Cambridge Waste Water Treatment Plant Relocation Project
Anglian Water Services Limited

Design Code

Application Document Reference: 7.17
PINS Project Reference: WW010003
APFP Regulation No. n/a

Revision No. **02**
19-February
202403
2nd April 2024

Figure 3.7 Concept sketches for the integration of the Gateway Building into the earth bank.

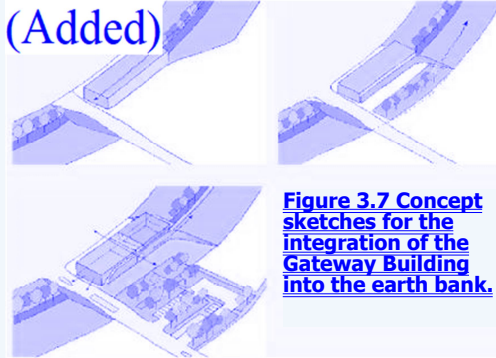
- The Gateway Building will be physically connected to the earth bank.
- The height of the masonry plinth will be the height of the earth bank, plus the height to provide falls protection to any walkways if required.

(Added)

Figure 3.10 Indicative Floor Layout as shown in App Doc Ref 4.10.1 showing gross internal area of 1225m²

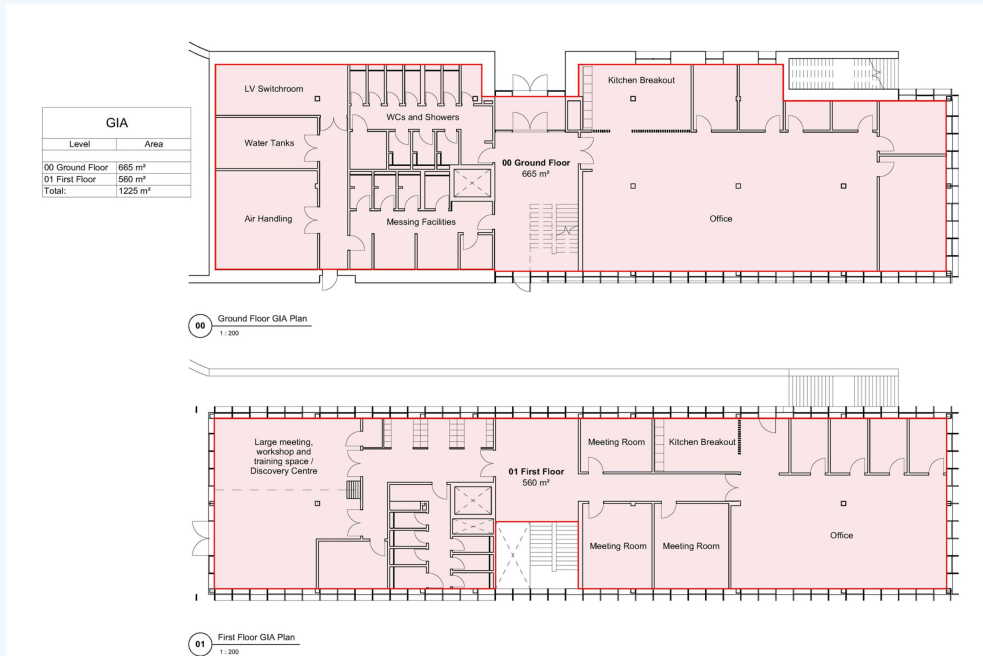
GBD.11

The Gross External Area over both floors of the Gateway building will not exceed 1473m². The Gross Internal Area of the Gateway Building over both floors will not exceed 1225m².

Figure 3.15 Extract of Figure 3.4 from the LERP

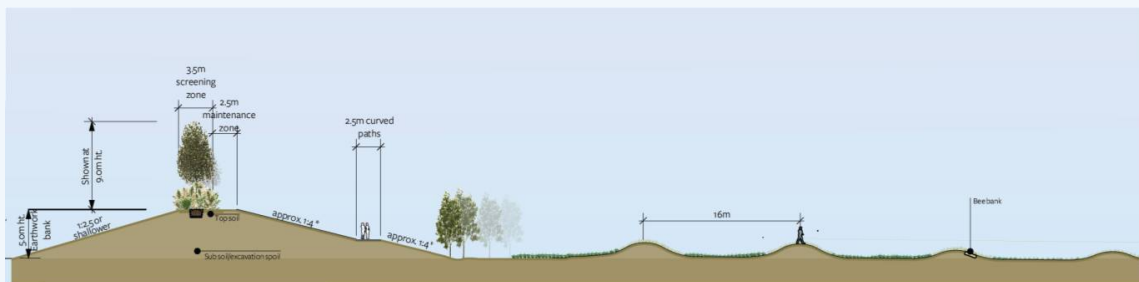
The earth bank will be a minimum of 5m above existing ground levels to provide natural screening. The earth bank profile will integrate with the surrounding landscape, with an outer slope between 1:2.5 and 1:5 where the landforms are at their widest and a steeper 1:2.5 (maximum) interior slope.

- In order to meet principles and objectives of sustainability, visual mitigation, and maintenance, as set out in the DAS.
- The earth bank top will be approximately level, with a slight slope or 'divot' toward the planting bed to direct surface runoff as additional irrigation and will include a 2.5m flat path clear of vegetation for maintenance.

- To assure the minimum height of 5m above existing ground level, a preliminary survey of the existing ground levels along the proposed centre line of the earth bank will be completed and included within the details submitted for approval under requirement 7 for the phase which included construction of the earth bank.

- The top of the earth bank will have a minimum of a 6m wide flat area for a vegetation screen and maintenance as shown in the LERP Figure 3.4.
- The details submitted will also include the proposed height of the finished level of the earth bank which shall include an allowance for a limit of deviation of +0.2m.

Figure 3.19 Example: Technical drawing of a vent stack

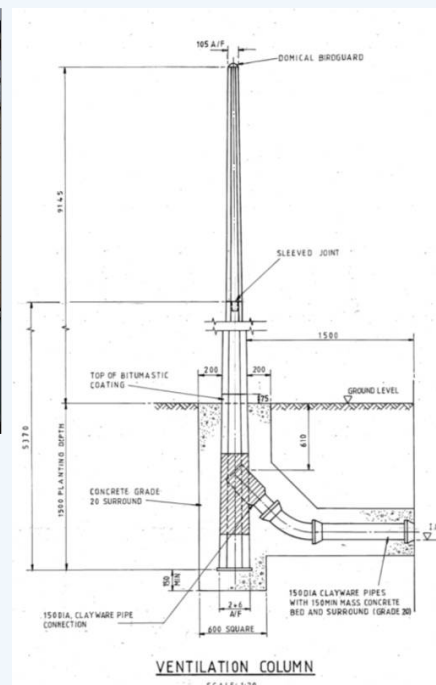
The ventilation stack and associated odour control unit at the interception shaft is to be designed with the follow-on development in mind. Coordination with the follow-on master developer regarding positioning and proximity to proposed development in their master plan must be completed. The stack must be at least 15m from an inhabited dwelling/building/office.

The interception shaft is a design feature that requires ventilation facilities. The purpose of the ventilation facility is to passively manage air pressure in the tunnel system, a process referred to as natural aspiration. Air would be drawn in under typical/normal operations and exit less frequently under extreme operating conditions. Potential odour could be released via the vent stack when air exits the tunnel system under extreme operating conditions. However, the vent stack included in the proposed WWTP would allow exiting air to be directed via a carbon air treatment filter. The carbon filtration is sufficient to control adverse odour during "extreme operating conditions". As the process is passive, and dependent upon air pressure within the sewer, it is not possible to accurately predict frequency or duration of air released from the ventilation facility, only to acknowledge that it would be intermittent, infrequent, and short-lived.
